THE MARYLAND-NATIONAL CAPITAL PARK AND PLANNING COMMISSION

MEMORANDUM

REVIEW TYPE: Mandatory Referral
APPLYING FOR: Modernization of Kensington-Parkwood Elementary School
APPLICANT: Montgomery County Public Schools (MCPS)
CASE NUMBER: 02502-MCPS-1
REVIEW BASIS: Article 28, Section 7-112 of the Annotated Code of Maryland

ZONE: R-60
LOCATION: 4710 Saul Road, Kensington, Maryland 20895
MASTER PLAN: 1989 Master Plan for the Communities of Kensington-Wheaton

Site Plan – New

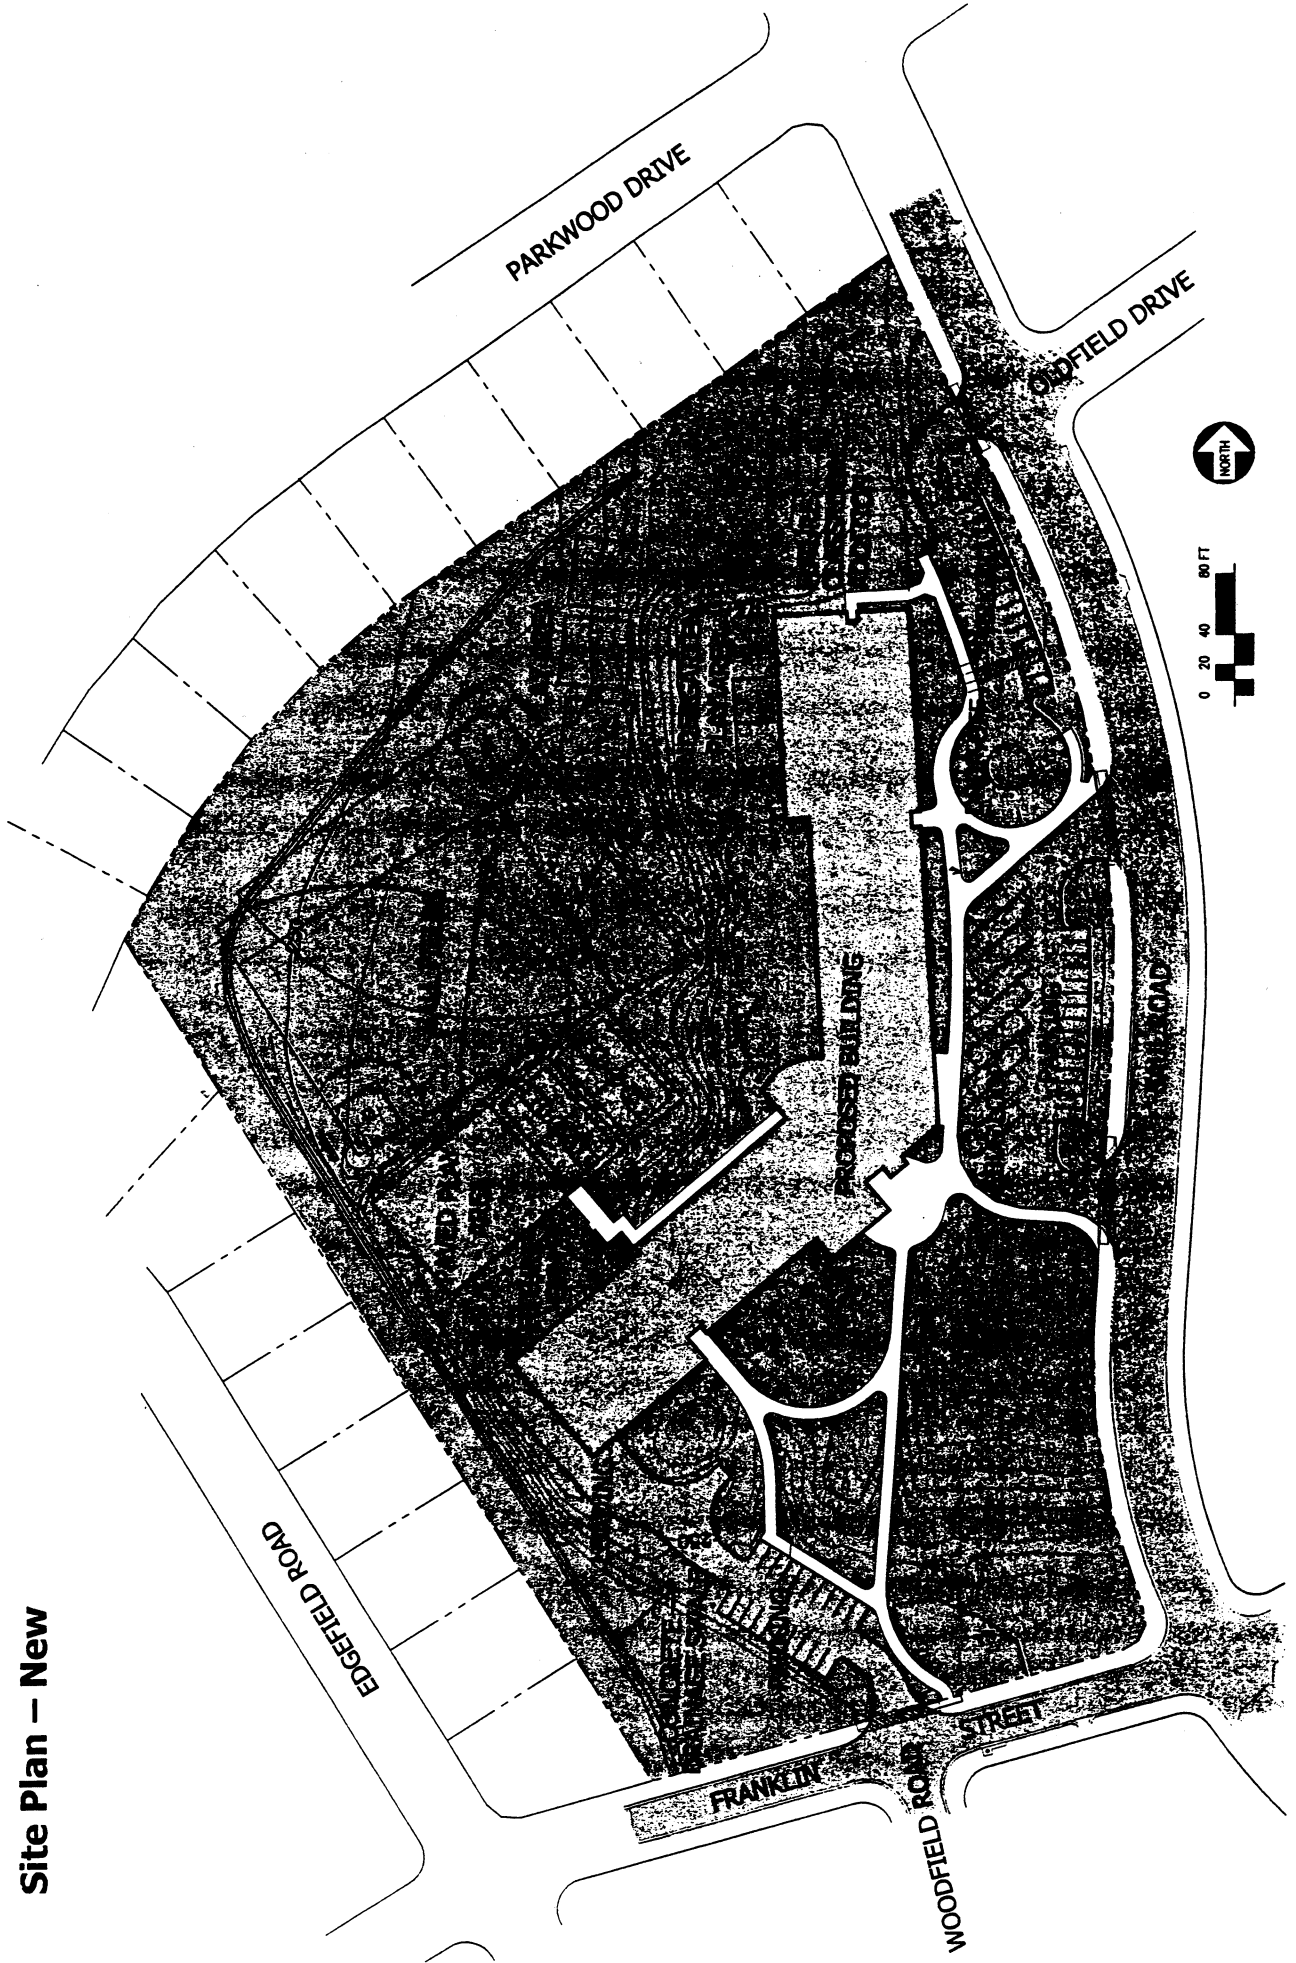
4. Reduce grading and utility work within critical root zones to a minimum;
5. Relocate the Saul Road drop-off and parking area to the front of the school to save healthy specimen trees; and

6. Reduce the width of drive entries, except for the bus loop, to 25 feet to save street trees and promote pedestrian safety.

The landscape, lighting, sediment and erosion control, and site development plans must be revised and submitted to staff for review to reflect verifiable tree conservation. Studying the separate sheets of the plans submitted, dated December 2001, trees proffered to be saved are in fact impacted by grading, utilities, and other site work. Staff is certain that a reduction in tree and green space loss can still be accomplished with adjustments to the plans and believes that saving large trees on this "school-park" site as well as in the public right-of-way is very important to the character of the community and to the environment of the school. For example, the specimen red oaks near the existing building and along Saul Road in the proposed parking area can be described as in perfect health. The tree (#14) 25 feet off the existing building has a garden under its canopy where teachers and volunteers have been observed teaching children gardening. Many other exceptional trees on site will be lost, yet a large grouping near Saul Road and Franklin Street, in serious decline or dead, is proposed to be saved. This is where staff would propose relocating the drop-off and teacher parking. Please refer to Attachment 6.
